KERR-McGEE CHEMICAL LLC

November 9, 1998

Subject: KMCLLC Response to Phase II Report Comments

**SUPPLEMENTAL PHASE II
WORK PLAN**

FIGURE 2-1

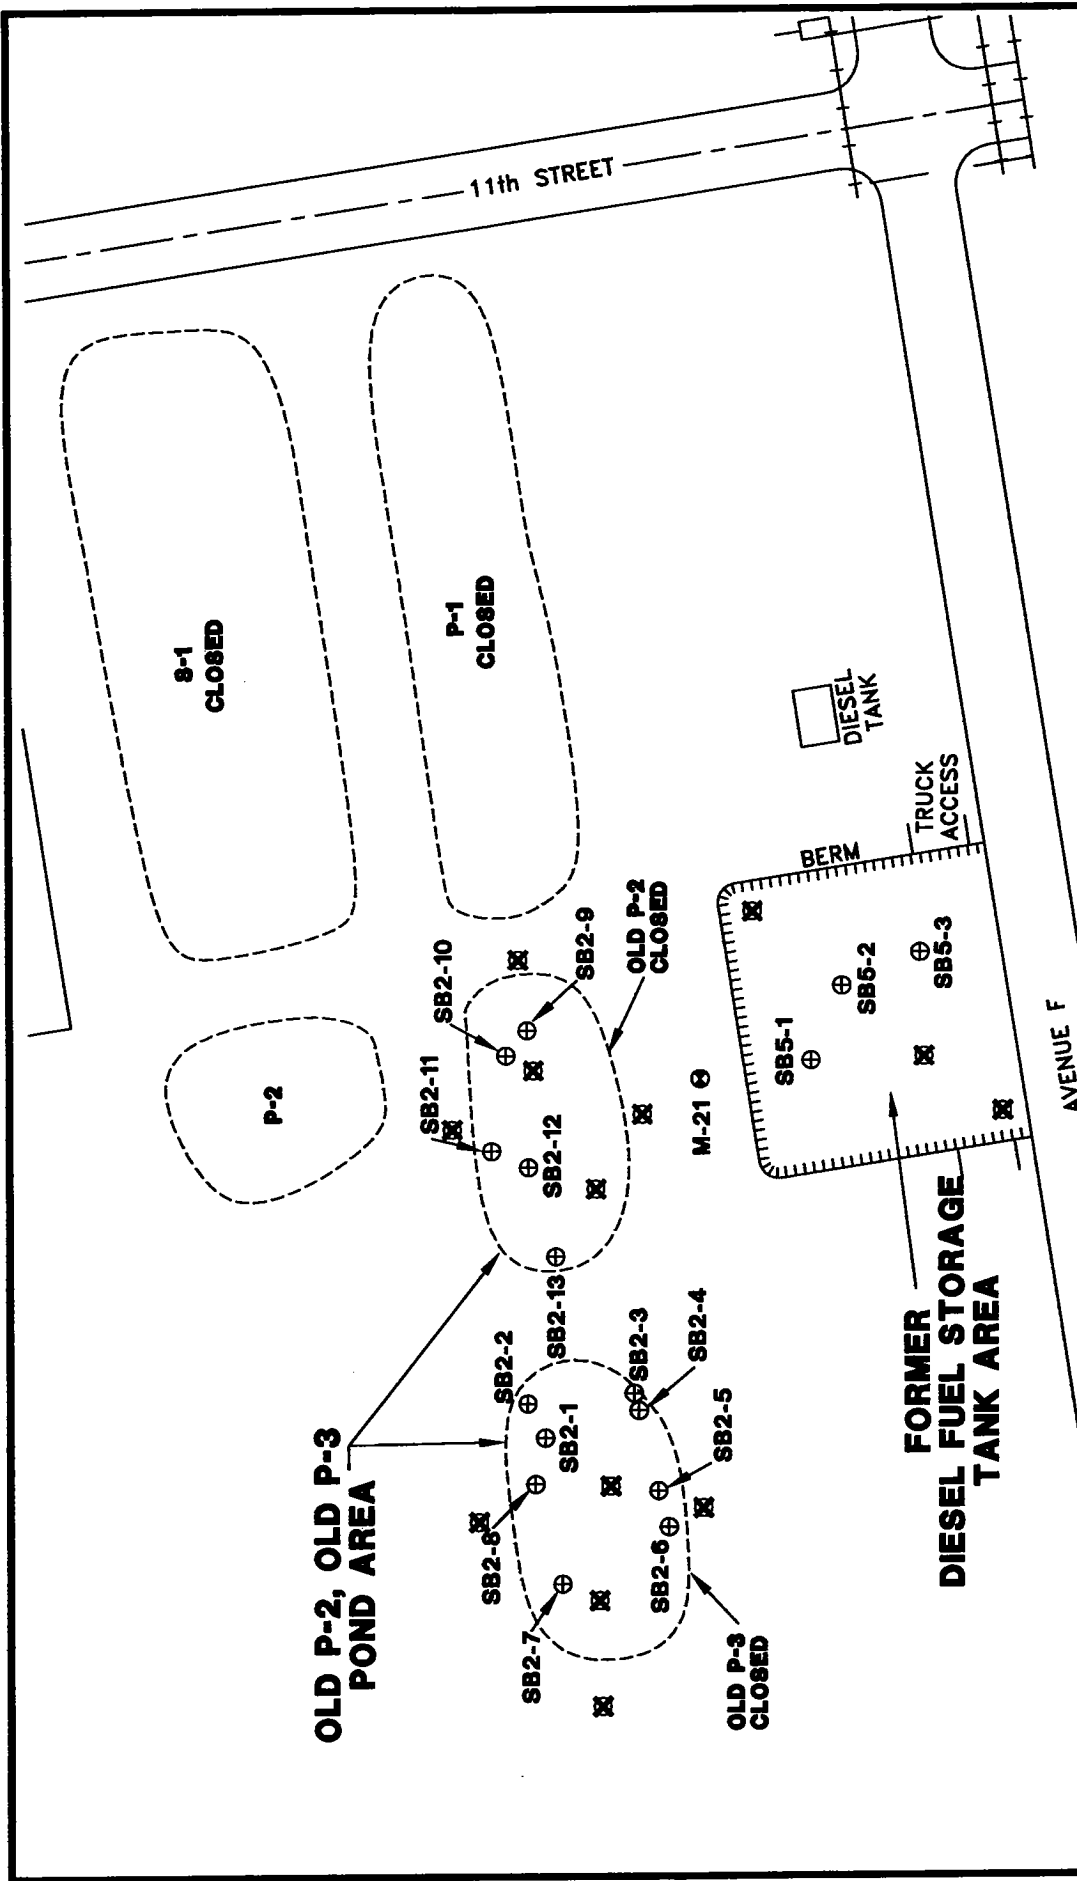
We agree that further work is required. More areal and subsurface definition is required. Please provide a workplan for the proposed work.

We agree that further work is required to determine the affected volume of soil. Please submit a workplan for this work.

We agree that groundwater from M-21 does not appear to be impacted by diesel; consequently no further monitoring well installation is required. However, TPH should be routinely sampled from M-21 in the future.

To define the areal extent of residual chromium resulting from the former use of the impoundments, eight borings will be advanced along the outer perimeter of the ponds (See Figure 2-1). The perimeter borings are proposed in locations that will enable the lateral and vertical limits of chromium in soil to be assessed. The perimeter borings are located just outside the berms encircling the chromium-containing soils within the Old P-2 and Old P-3 Ponds, Figure 2-1. The perimeter

Four additional borings will be advanced in a similar manner within the interior boundaries of the former ponds (see Figure 2-1). The interior borings are located near areas of earlier chromium detection and are intended to confirm the extent of vertical chromium migration in soil, and to assess whether chromium-containing soils extend to the depth of groundwater. Sampling will be conducted at two-foot intervals to the capillary fringe anticipated to be approximately 40 feet bgs. Samples will be analyzed for pH and total chromium until two successive samples are determined to be less than 100 mg/kg of total chromium.

Four additional borings will be advanced in the Diesel Fuel Storage Tank bermed area (see Figure 2-1). The four borings are located to surround previous borings which detected TPH-d, and to confirm the limits of diesel in soil. The borings will be advanced using a hollow-stem auger drill rig to the capillary fringe or an approximate depth of 40 feet bgs. Samples will be collected via a split-spoon sampler on five-foot intervals to the terminal depth at the capillary fringe.

At the request of NDEP to confirm no impacts to groundwater, a groundwater sample will be collected from M-21 (see Figure 2-1) during the upcoming field activities described above at the Old P-2 and Old P-3 Ponds and Diesel Fuel Storage Tank.
